Grapes Hill Roundabout Area

Proposed changes

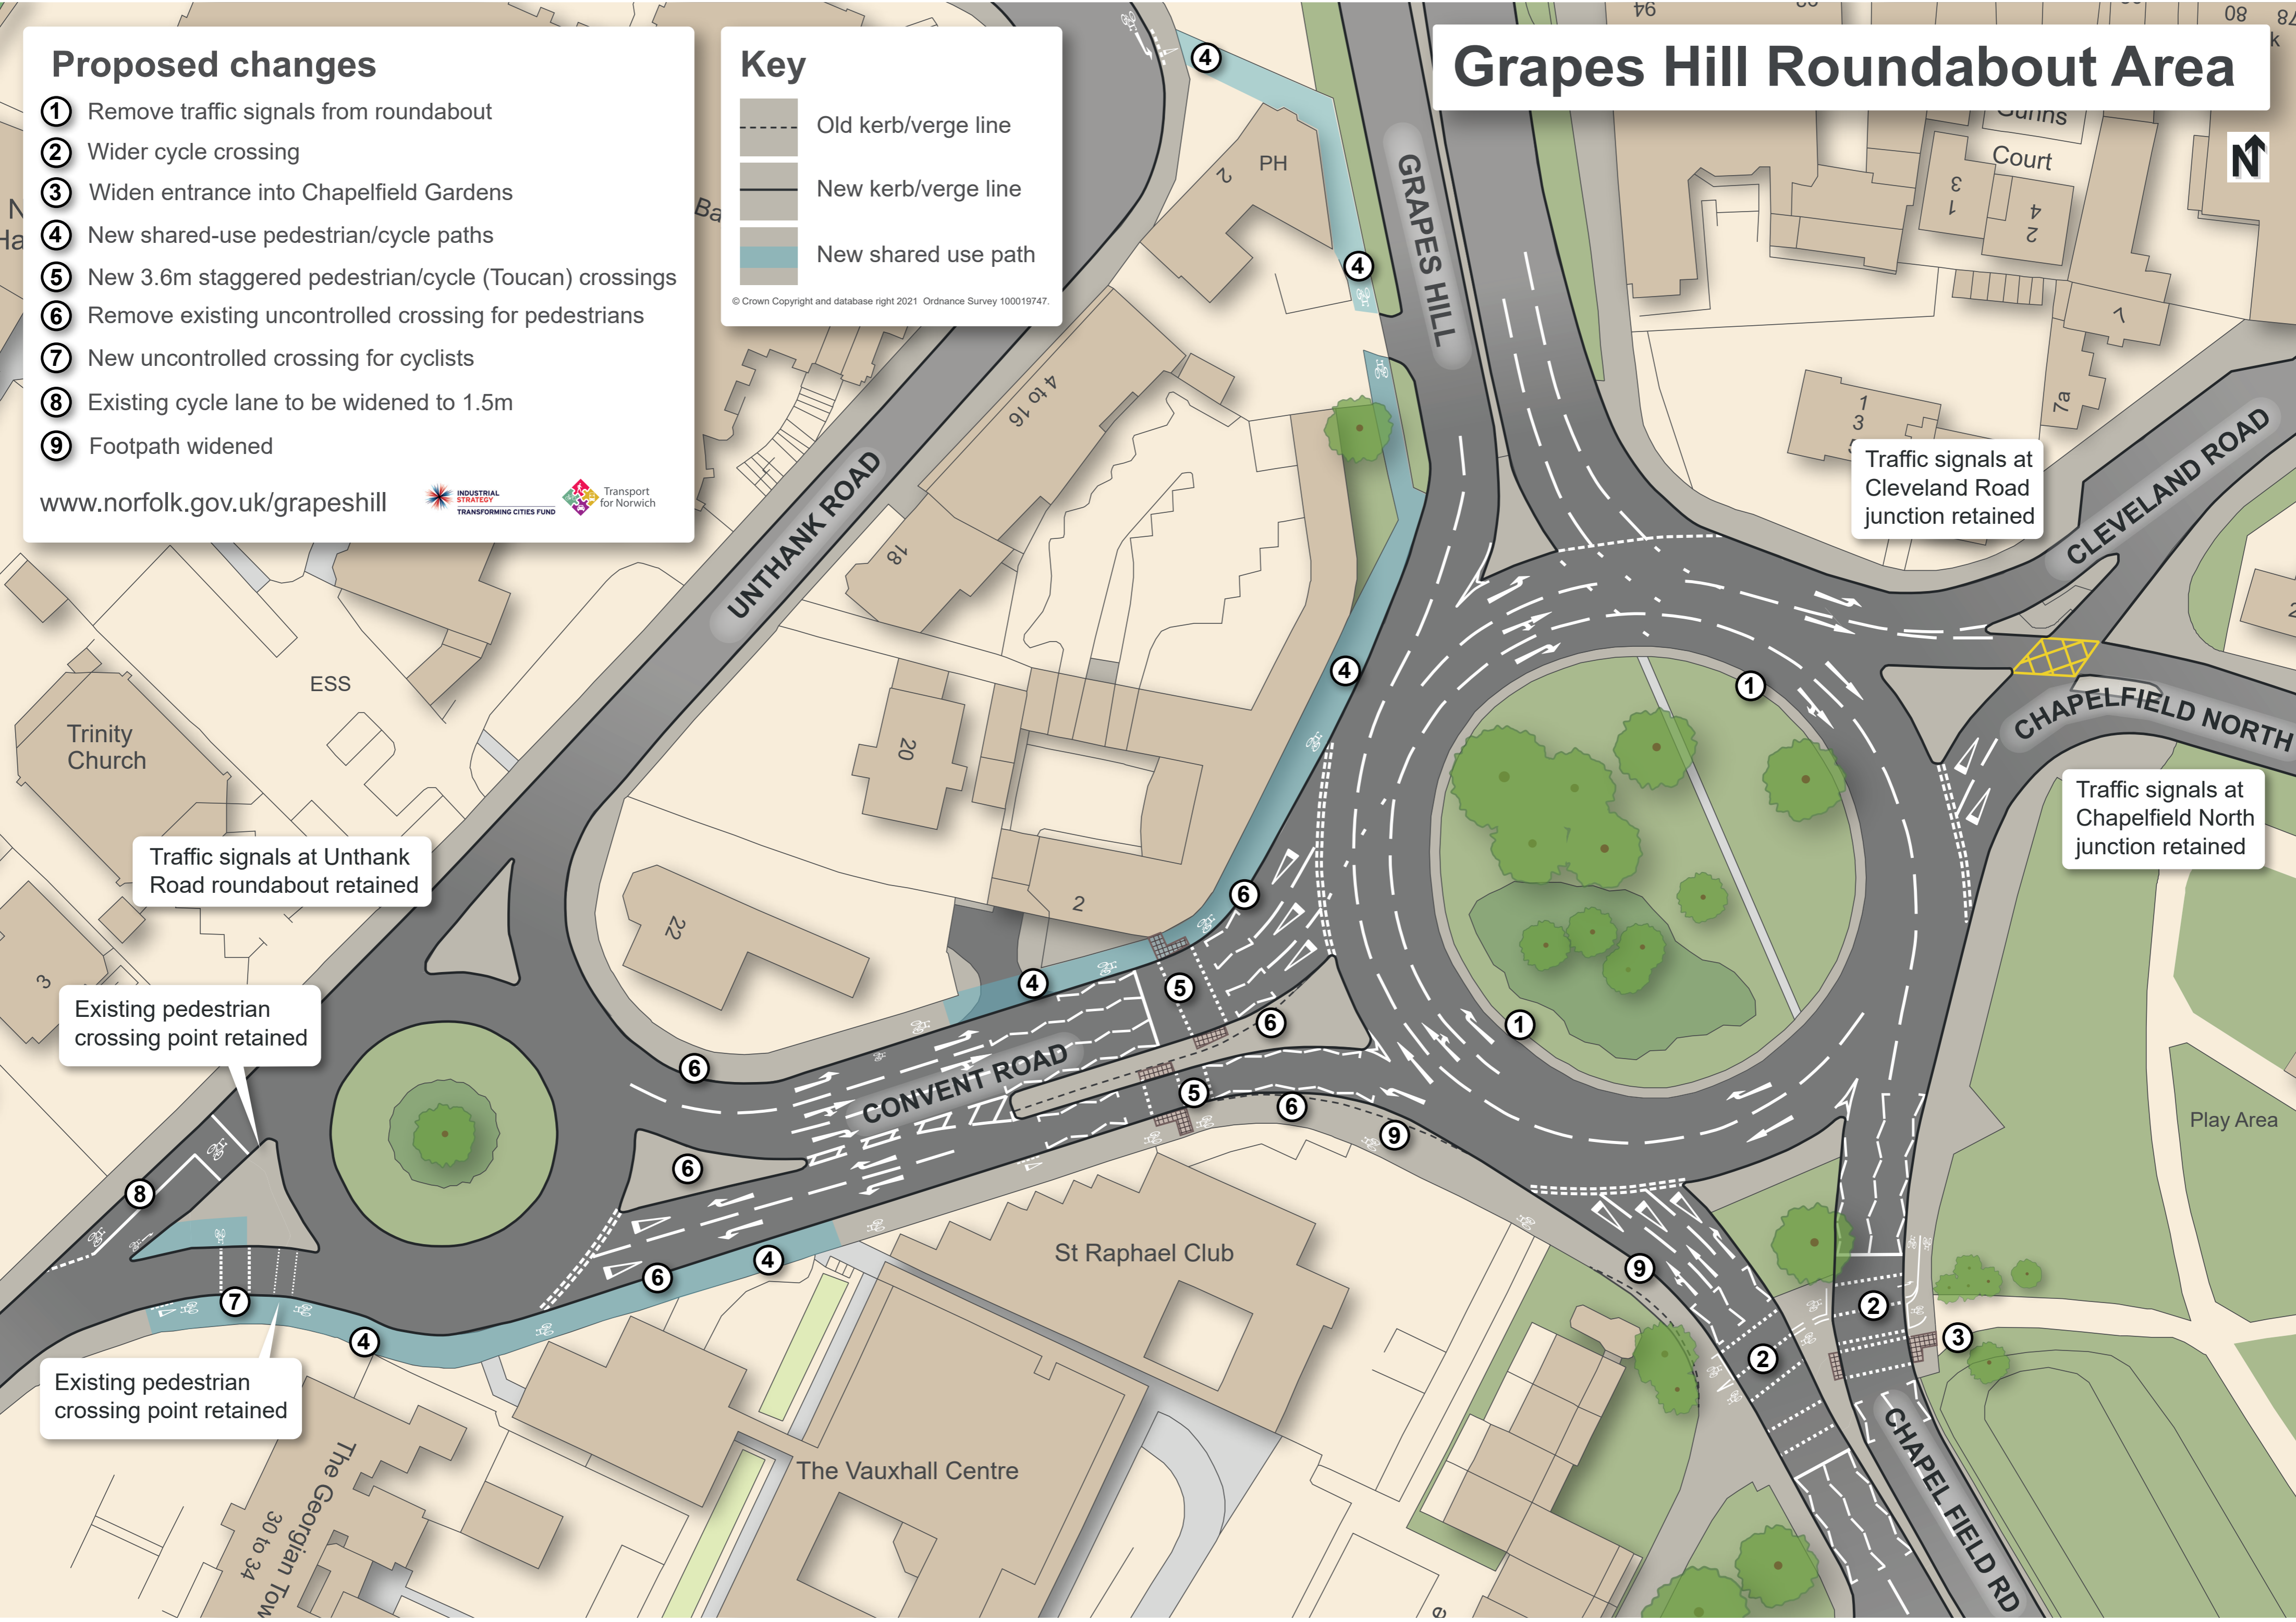
- ① Remove traffic signals from roundabout
- ② Wider cycle crossing
- ③ Widen entrance into Chapelfield Gardens
- ④ New shared-use pedestrian/cycle paths
- ⑤ New 3.6m staggered pedestrian/cycle (Toucan) crossings
- ⑥ Remove existing uncontrolled crossing for pedestrians
- ⑦ New uncontrolled crossing for cyclists
- ⑧ Existing cycle lane to be widened to 1.5m
- ⑨ Footpath widened

Traffic signals at Unthank Road roundabout retained

Existing pedestrian crossing point retained

Existing pedestrian crossing point retained

Traffic signals at Cleveland Road junction retained

Traffic signals at Chapel Field North junction retained
